Staff Analysis:

2. MPA/TMC/SAHBA Proposal – Master Sign Program - Best Practice Option:

4. MPA/TMC/SAHBA Proposal from November 29th letter:

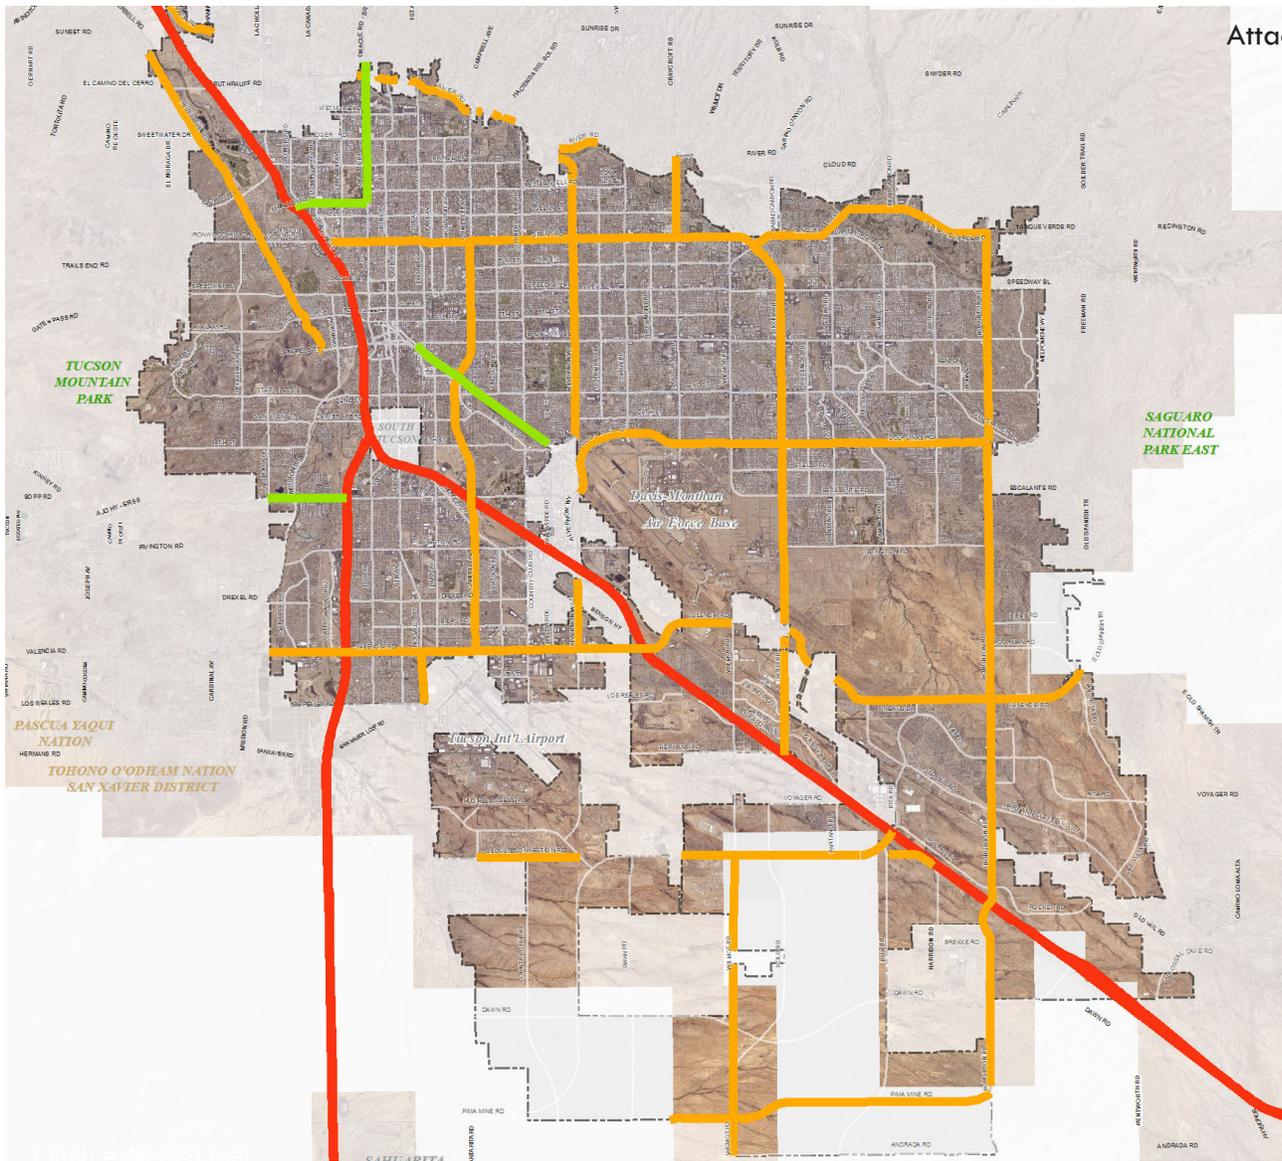
In the current proposed ordinance, the definition of freeway is defined as Freeways designated on the Major Streets and Routes Plan. **REQUEST: For consistency, modify this definition to correspond with the Major Streets and Routes Map and clarify that it includes extensions and proposed new state Highways such as Aerospace Parkway and Sonoran Corridor.**

In the current proposed ordinance, there is an underlying 2-tier system of roadways; freeways and all other local neighborhood streets and arterial roadways. **REQUEST: Create a 3-tier system. Add a definition for State Routes: to include State Routes and selected Regional Arterials to correspond to the City of Tucson approved PAG Regionally Significant Corridors Study**

The proposed changes to the definition of Freeway, and the addition of the definition of State Routes, would allow for a significant increase in signage throughout the City. The standards related to freeways are intended for signs along an Interstate, not PAG regional routes or State Routes.

This proposal would allow in the 7A Sign Standards General Standards for freestanding signs, regardless of lot size, that are 48 feet tall and 360 square feet in areas along Miracle Mile, Oracle Road, Ajo Way

and Barraza Aviation Parkway, and would remove the requirement to adhere to scenic corridor regulations.

Additionally, it would create a new category named State Routes that would allow in the 7A General Standards for freestanding signs, regardless of lot size, that are 24 feet tall and 180 square feet in area along River Road, Grant Road, Kino Parkway/Campbell Road, Alvernon Way, Old Nogales Highway, Wilmot Road, Kolb Road, Silverbell Road, Houghton Road, Valencia Road, and Golf Links Road, and would also remove the requirement to adhere to scenic corridor regulations. These are all areas where the current sign standard allows for a sign that is 12 feet tall and 72 square feet in area. **[For a graphical representation of the areas impacted by this proposal, please see Attachment A]**

This proposal would allow for signs that are 48 feet tall and 360 square feet in area along Miracle Mile, Oracle Road, Houghton Road and Barraza Aviation Parkway (in green above), and would remove the requirement of the Scenic Corridor Regulations. Additionally it would create a new category named 'State Routes' that would allow for signs that are 24 feet tall and 180 square feet in area along River Road, Grant Road, Kino Parkway/Campbell Road, Alvernon Way, Old Nogales Highway, Wilmot Road, Kolb Road, Silverbell Road, Houghton Road, Valencia Road, and Golf Links Road and would also remove the requirement of the Scenic Corridor Regulations.. These are all areas where the current sign standard allows for a sign that is 12 feet tall and 72 square feet in area.
